THE FACTORY

APRIL 2021

PLANNING DRAWINGS

FACTORY MANCHESTER

PROPOSED GROUND FLOOR PLAN

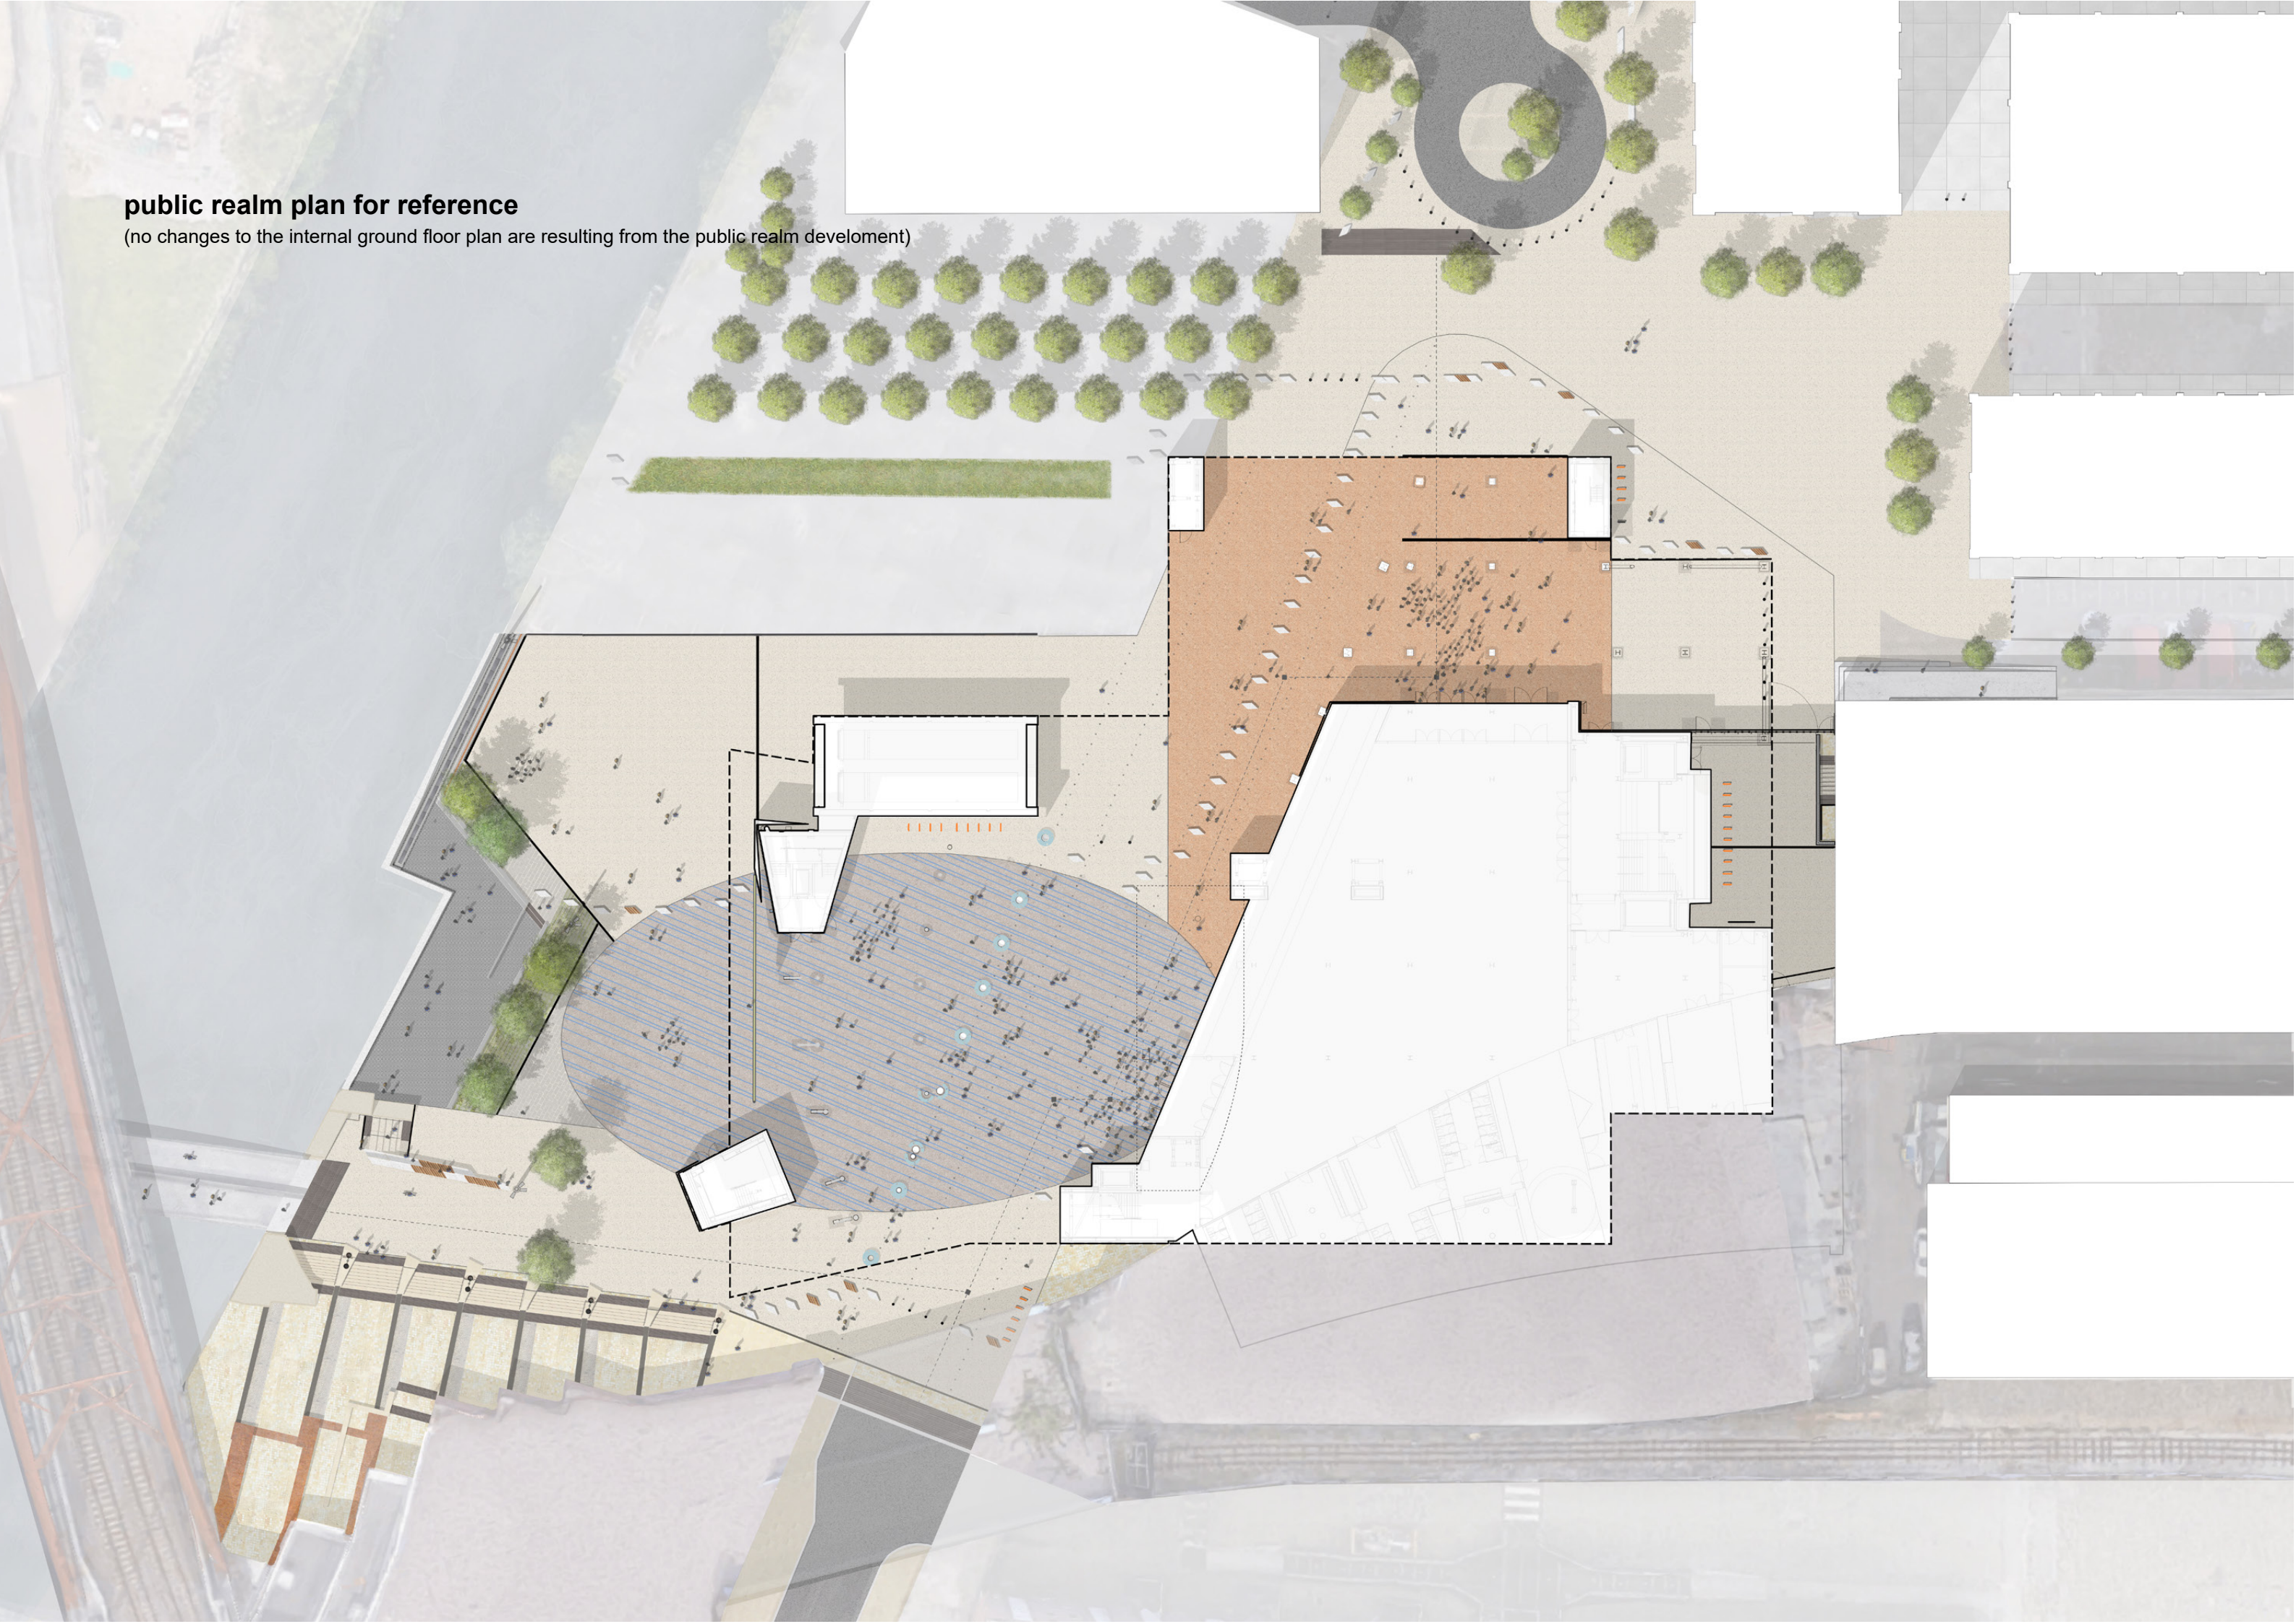
(no changes to the internal ground floor plan are resulting from the public realm development)

1 NORTH ELEVATION
SCALE: 1:200

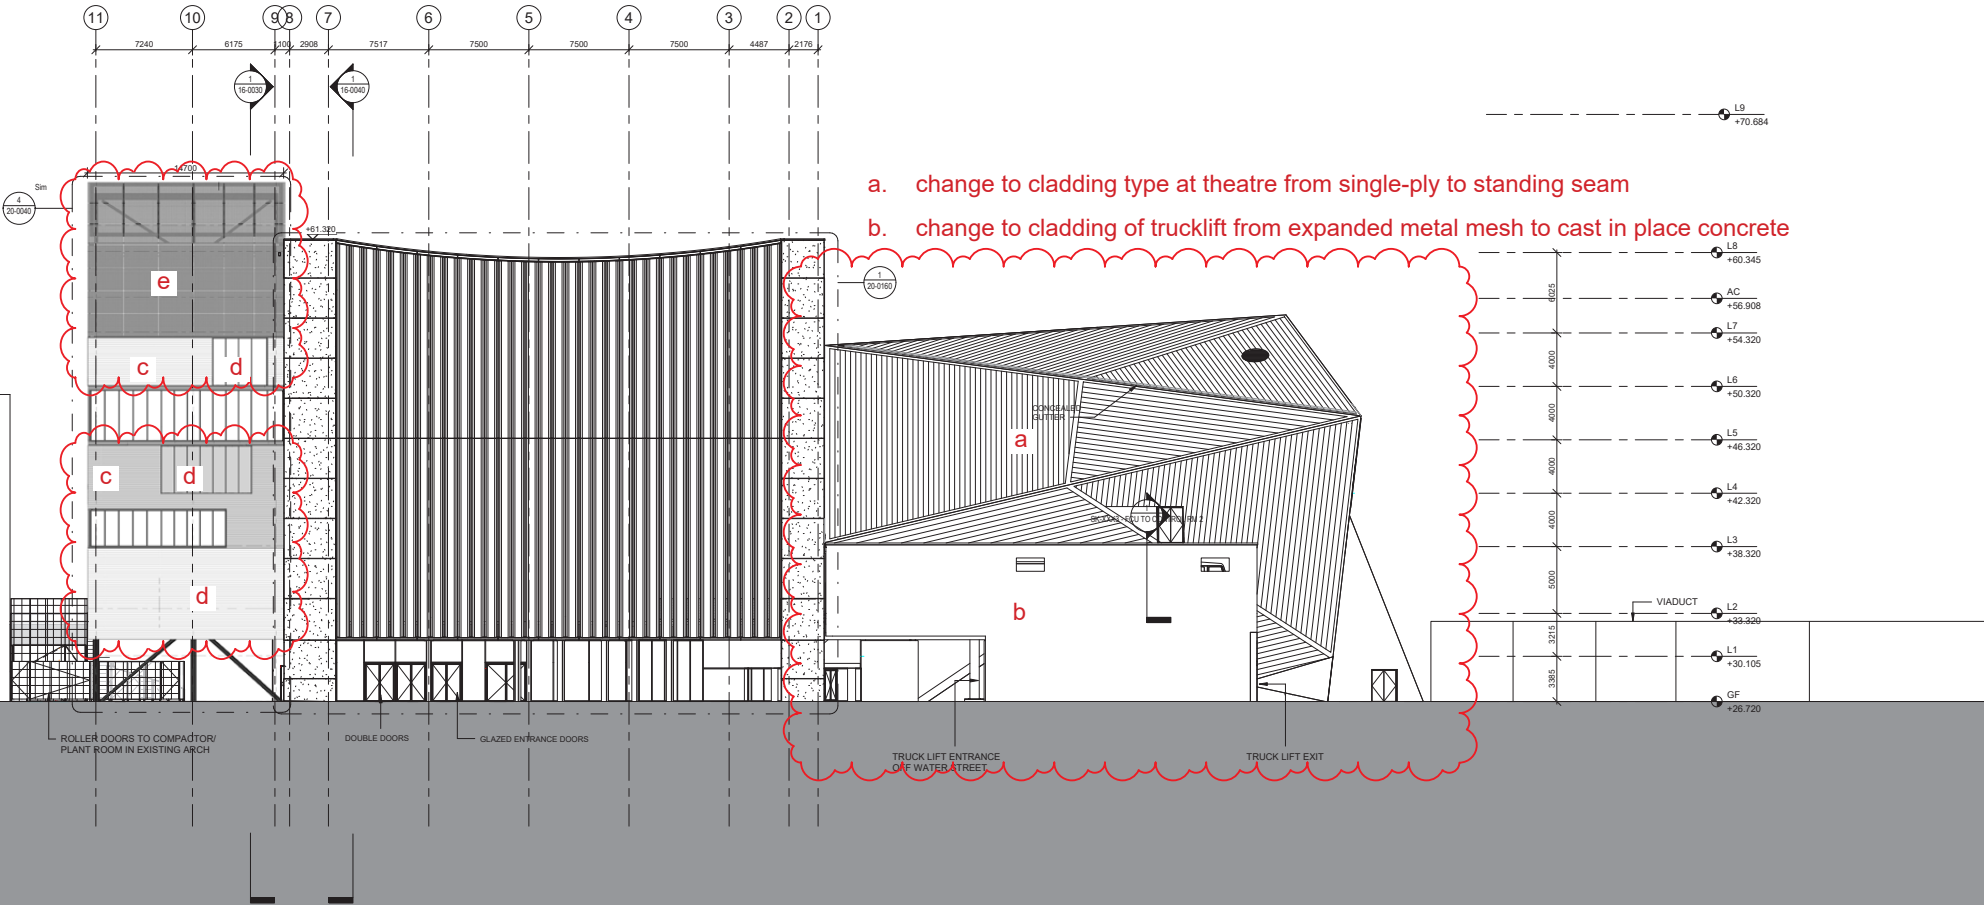
- c. change from vertical to horizontal orientation of sinusoidal cladding
- d. change of channel glass to fritted translucent curtain wall
- e. change of metal mesh from elephant grid to expanded metal mesh

DRAWN BY	Author	CHECKED BY	Checker	APPROVED BY	Approver
PROPOSED EAST ELEVATION					
DRAWING NAME					
PHASE					
P10 REVISION					
XXXX					
1:200					
A0					
05/31/16					
DATE					
MF-OMA-XX-XX-DR-A-18-0020					
DRAWING NUMBER

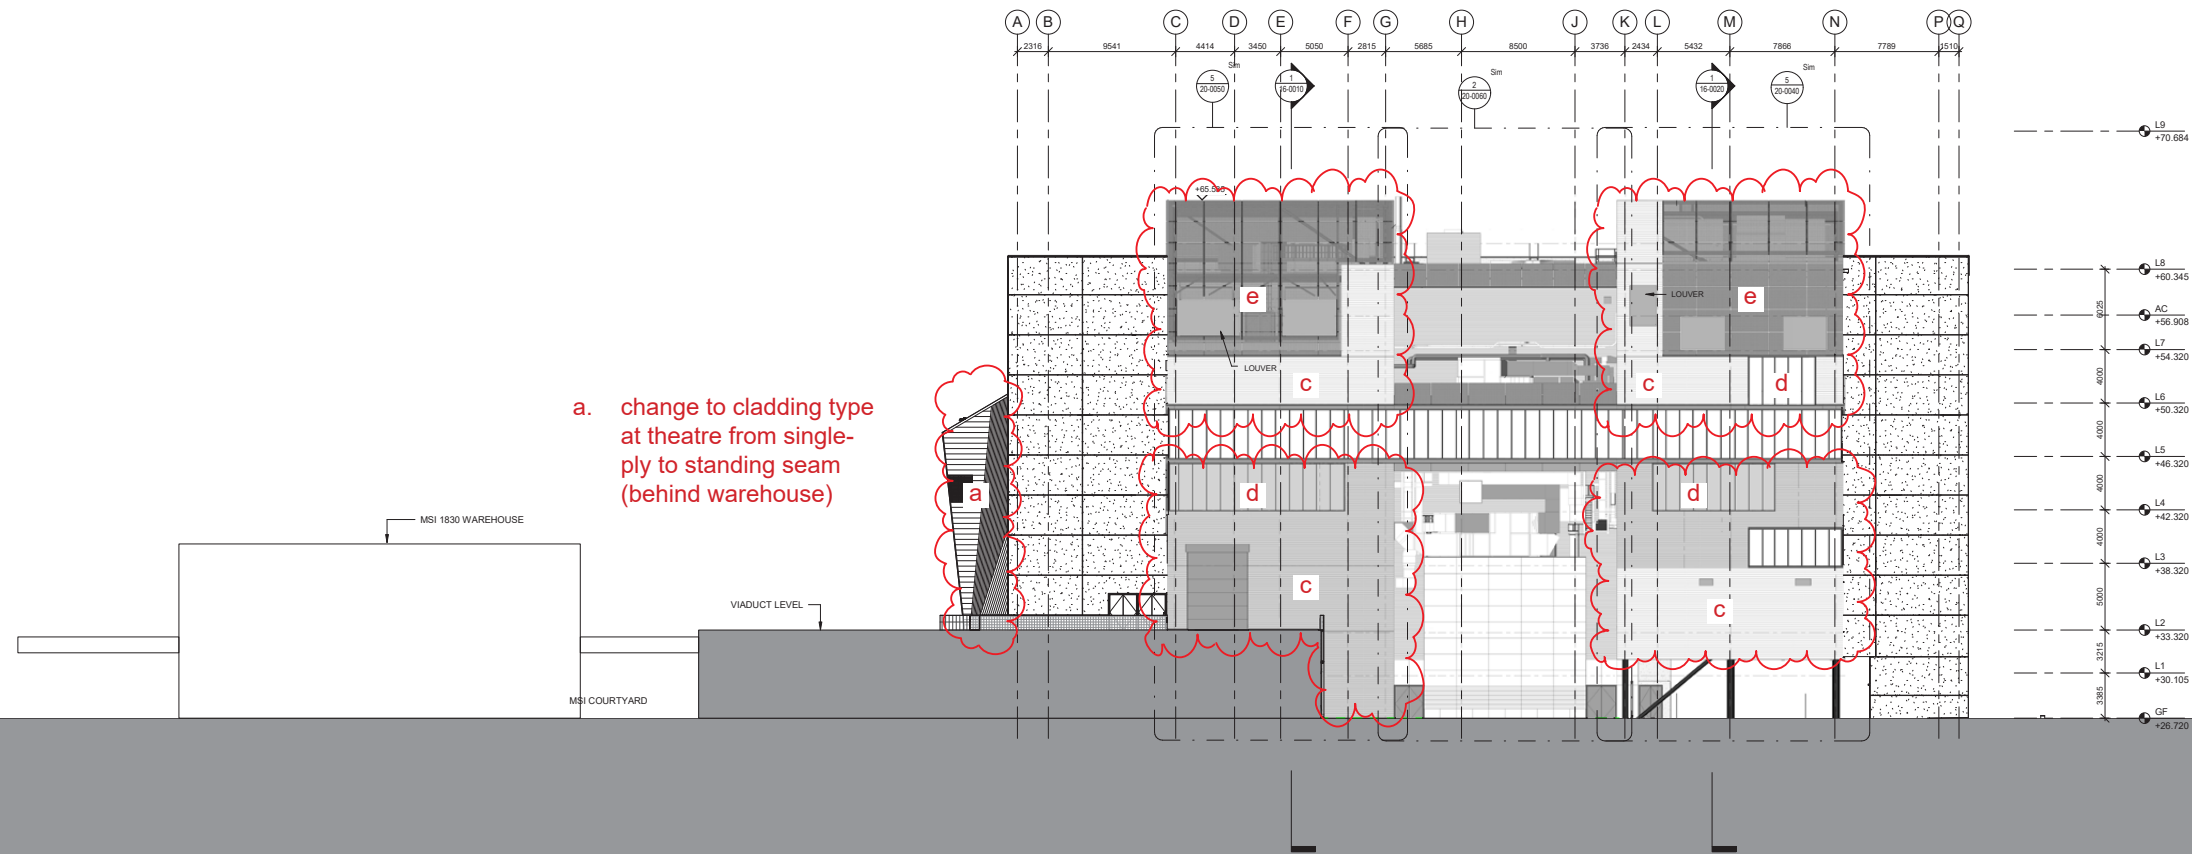
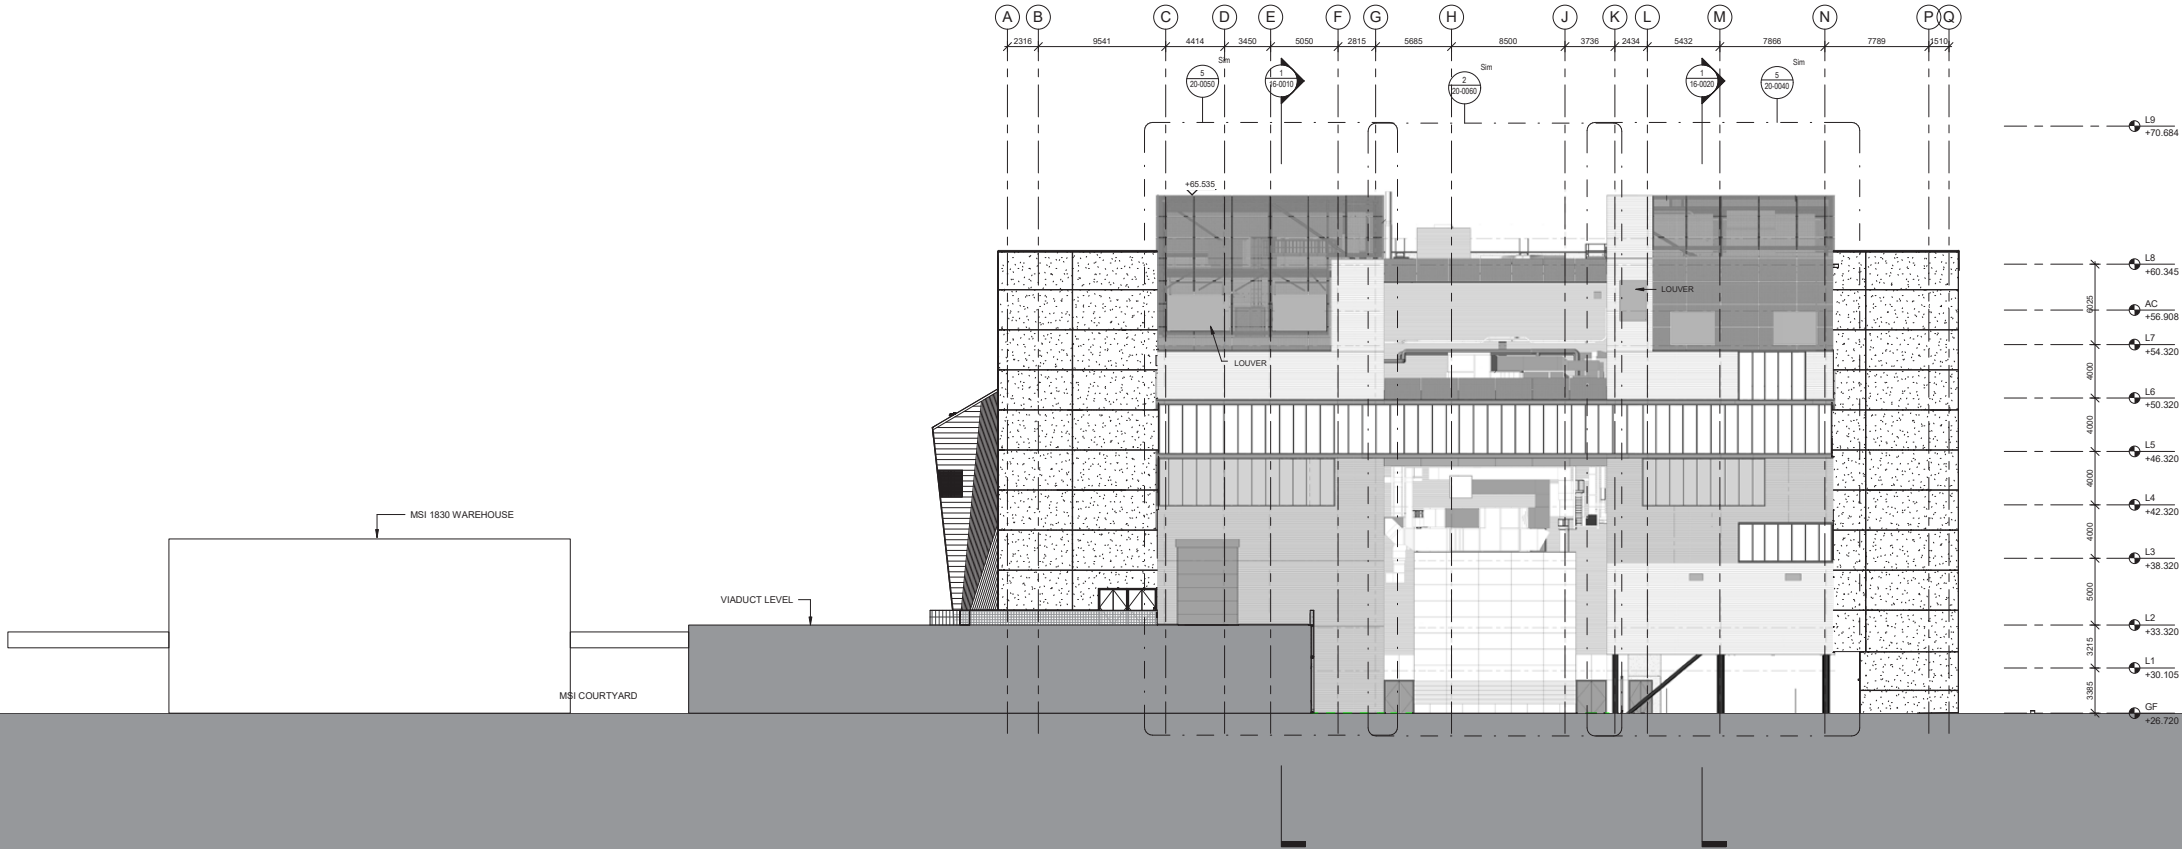
a. change to cladding type at theatre from single-ply to standing seam (behind warehouse)

c. change from vertical to horizontal orientation of sinusoidal cladding

d. change of channel glass to fritted translucent curtain wall

e. change of metal mesh from elephant grid to expanded metal mesh

1 SOUTH ELEVATION
SCALE: 1:200

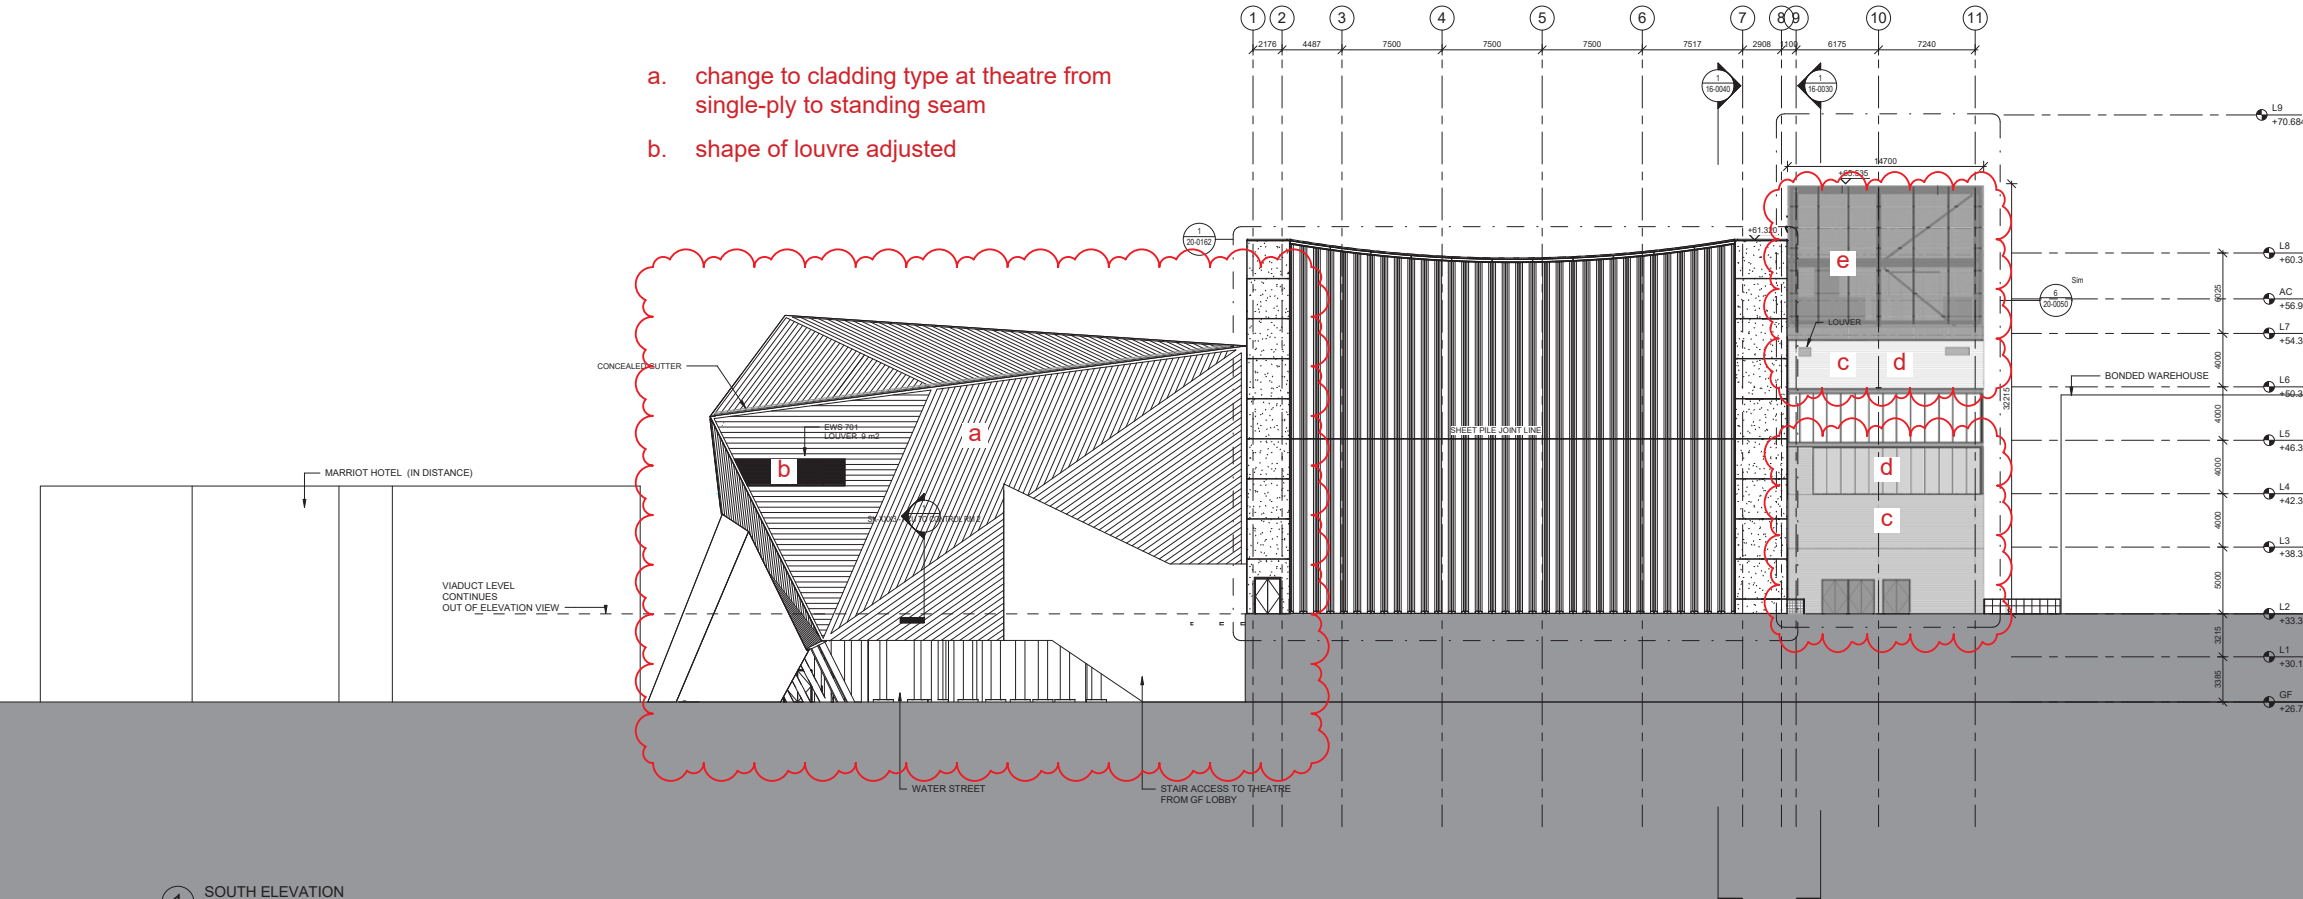
- a. change to cladding type at theatre from single-ply to standing seam
- b. shape of louvre adjusted

- c. change from vertical to horizontal orientation of sinusoidal cladding
- d. change of channel glass to fritted translucent curtain wall
- e. change of metal mesh from elephant grid to expanded metal mesh
